014

Technical Bulletin

PowerGrip® Kit K015432XS for Fiat and Lancia 1.6 petrol engines

Fig. 4

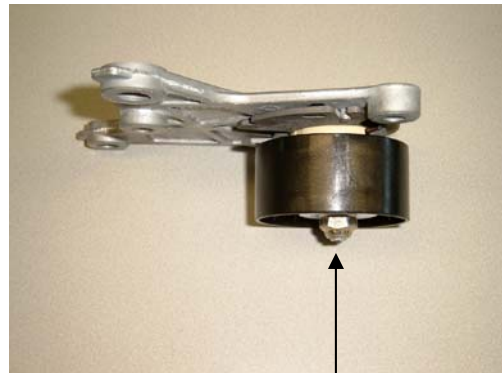
It may be possible that the tensioner on the car is still an older model. There is no problem to install the latest version tensioner with the old stud and nut. Although the depth of the fixing hole (A) of the tensioner is deeper and the stud stays the same, there is still enough room on the stud to fix the nut properly, see Fig. 5 (B).

Fig. 4 and Fig. 5 show the latest version of the tensioner fixed on the bracket. Normally this bracket (C) is mounted on the engine block and does not have to be removed.

Fig. 6

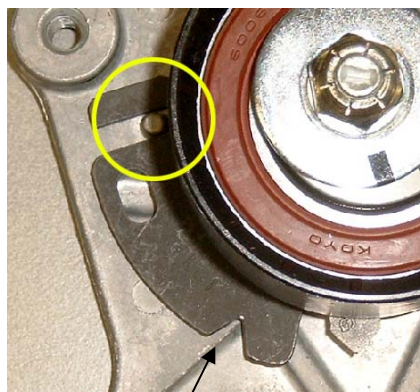
To lock the tensioner, position the open oblong hole in the base plate of the tensioner on the pin on the bracket (Fig. 6).
